CITY OF COLD LAKE **AQUATICS CENTRE**

CONCEPT DESIGN REPORT
OCTOBER 03, 2022

Level Playing Field (LPF) feels privileged to have the opportunity to work with TBD Architecture + Urban Planning to provide our expertise in accessible design for the Cold Lake Aquatic Centre. This building will serve an important community need and we want to help ensure its design provides an inclusive, safe, and enjoyable experience for all visitors, and staff.

In this report we have completed a review of the schematic design drawings and provided comments and recommendations that will contribute to the projects overall success. Our goal is to work closely with the TBD Architecture + Urban Planning to ensure that the building is meaningfully accessible and user-centric. Buildings such as this provide an excellent opportunity to set an example for accessibility and inclusion given its intended use, purpose, and clientele.

5.1.2 PLAN LEVEL 02

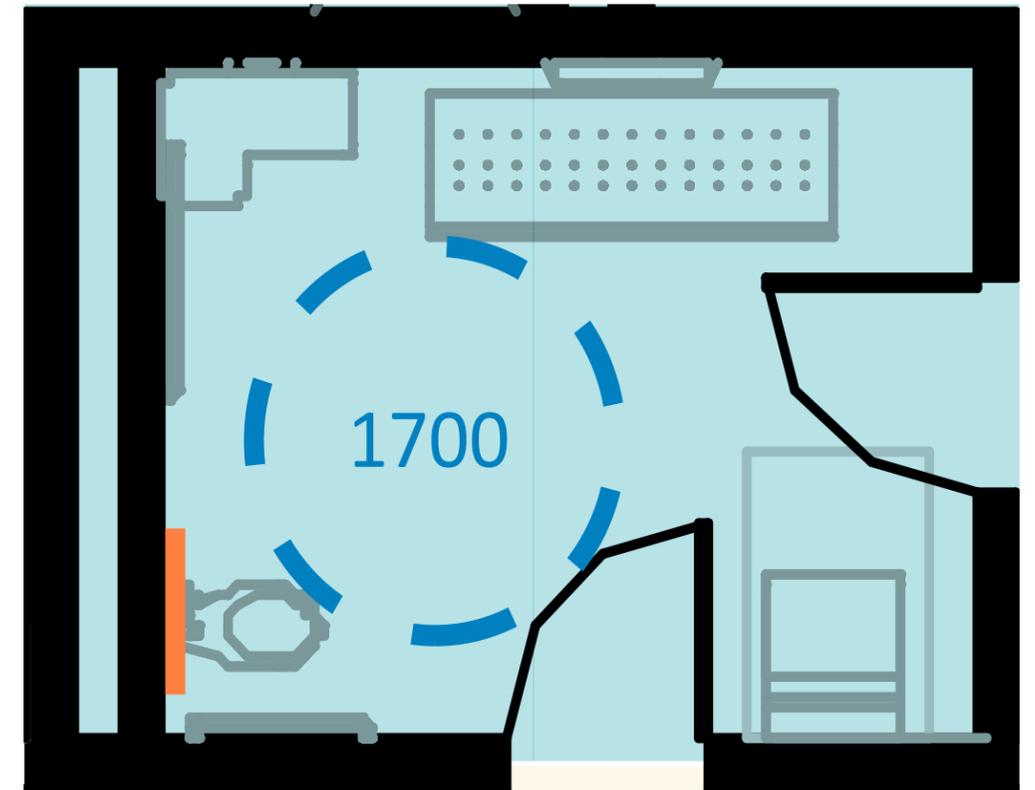
Ensure a 50mm colour contrasting strip on le edge of each tread, th width of the stair typ.

5.2.5 NATATORIUM

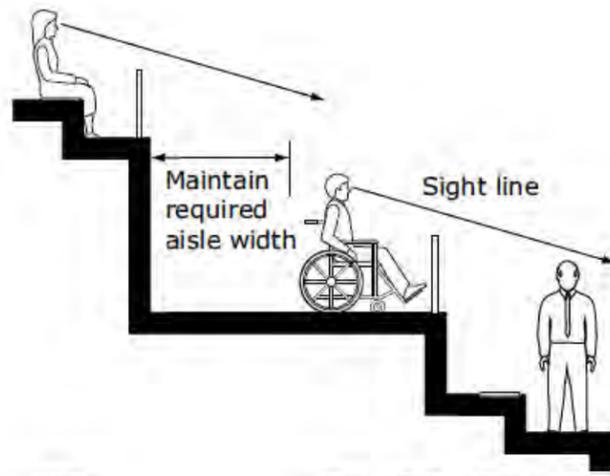
- Ensure a clear path of travel is maintained in the pool viewing area
- Ensure that the line of sight is not reduced or obstructed by guard rails, and is comparable to those for all viewing positions
- A viewing space for a person using a wheeled mobility device shall have a clear floor area of at least 850 x 1350mm and on a clear and level surface
- LPF best practice recommends that some change rooms with proximity to the natatorium entrance be dedicated as limited mobility. These can be standard sized, but provide additional grab bar support and backframing for said grab bars
